Proposal for amendments to Regulation No. 10 (Electromagnetic compatibility)

Submitted by the experts from the Russian Federation

The text reproduced below was prepared by the experts from the Russian Federation to amend Regulation No. 10 with prescriptions for trolleybuses. It is based on ECE/TRANS/WP.29/GRE/2014/41 and GRE-73-20 introduced at the seventy-second and seventy-third sessions of GRE. The modifications to the existing text of the Regulation are marked in bold for new or strikethrough for deleted characters.

«Addendum 9

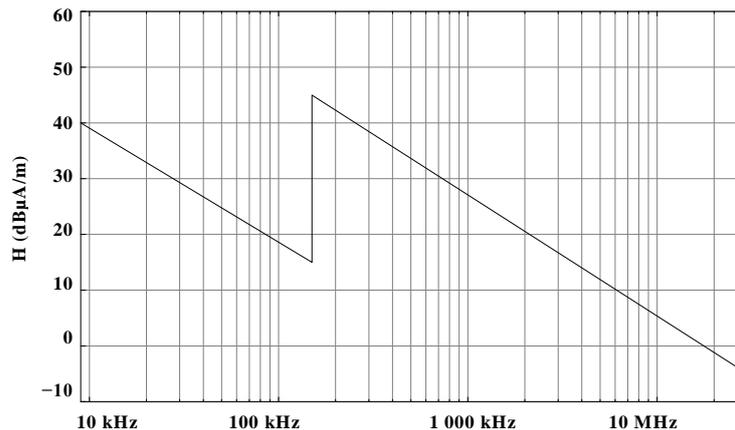
Limit H (dB μA/m) at frequency F (MHz):	
0,009–0,150 MHz	0,150–30 MHz
$H = 40 - 20,46 \cdot \log (F/0,009)$	$H = 45 - 21,73 \cdot \log (F/0,15)$

Limit values for interference created by the trolleybus in the stationary state, trolleybus-to-antenna spacing of 10 m
 Quasi-peak detector: bandwidth 200 Hz for f < 150 kHz
 bandwidth 10 kHz for f > 150 kHz

Frequency (logarithmic scale)
 (See paragraphs 6.2.2.3.1 and 6.2.2.3.3 of this Regulation)

Addendum 10

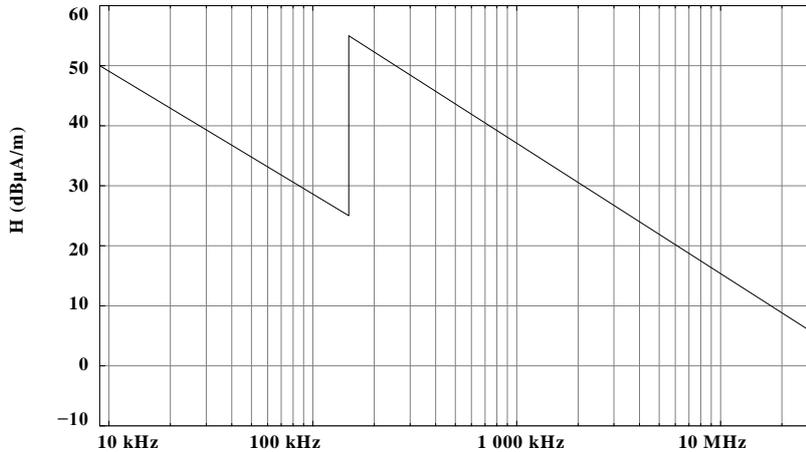
Broadband reference limits for the interference created by the trolleybus in a driving mode

Limit H (dB μ A/m) at frequency F (MHz):	
0,009–0,150 MHz	0,150–30 MHz
$H = 50 - 20,46 \cdot \log (F/0,009)$	$H = 55 - 21,73 \cdot \log (F/0,15)$

Limit values for interference created by the trolleybus in the driving mode,
trolleybus-to-antenna spacing of 10 m
Peak detector: bandwidth 200 Hz for $f < 150$ kHz
bandwidth 10 kHz for $f > 150$ kHz

Frequency (logarithmic scale)
(See paragraphs 6.2.2.3.2 and 6.2.2.3.4 of this Regulation)

Addendum 11

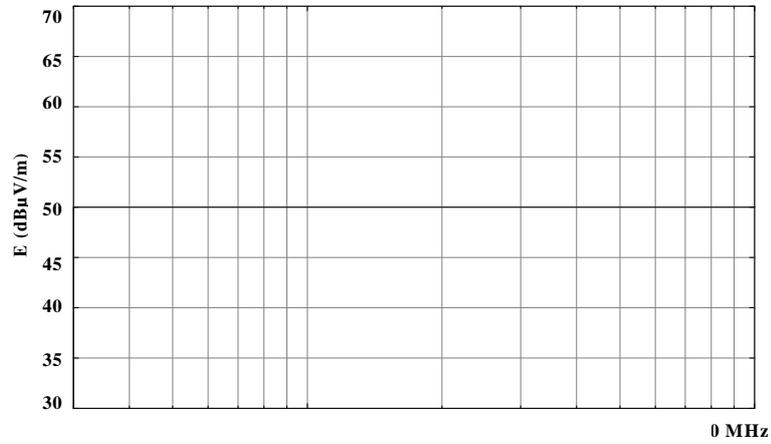
Broadband reference limits for the interference created by the trolleybus in a stationary state

Limit E (dB μ V/m) at frequency F (MHz):
30–1 000 MHz
E = 50

Limit values for interference created by the trolleybus in the stationary state,
 trolleybus-to-antenna spacing of 10 m
 Quasi-peak detector: bandwidth 120kHz

Frequency (logarithmic scale)
 (See paragraph 6.2.2.3.5 of this Regulation)

Addendum 12

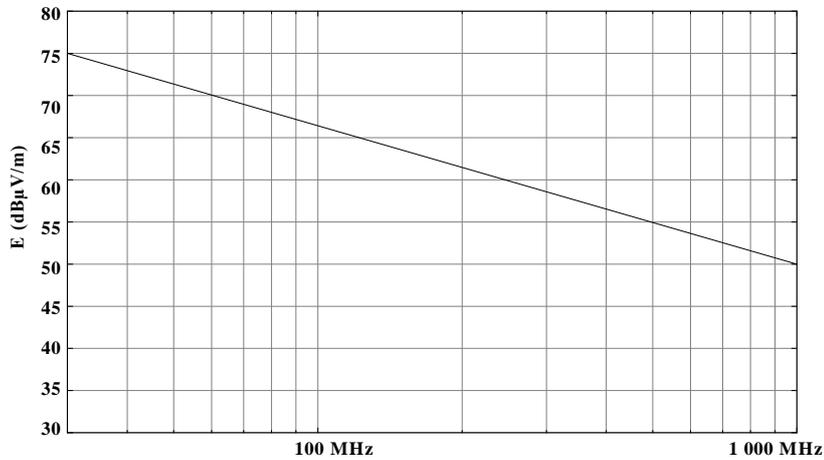
Broadband reference limits for the interference created by the trolleybus in a driving mode

Limit E (dBµV/m) at frequency F (MHz):
30 – 1 000 MHz
$E = 75 - 16,42 \cdot \log (F/30)$

Limit values for interference created by the trolleybus in a driving mode,
 trolleybus-to-antenna spacing of 10 m
 Peak detector: bandwidth 120kHz

Frequency (logarithmic scale)
 (See paragraph 6.2.2.3.6 of this Regulation)
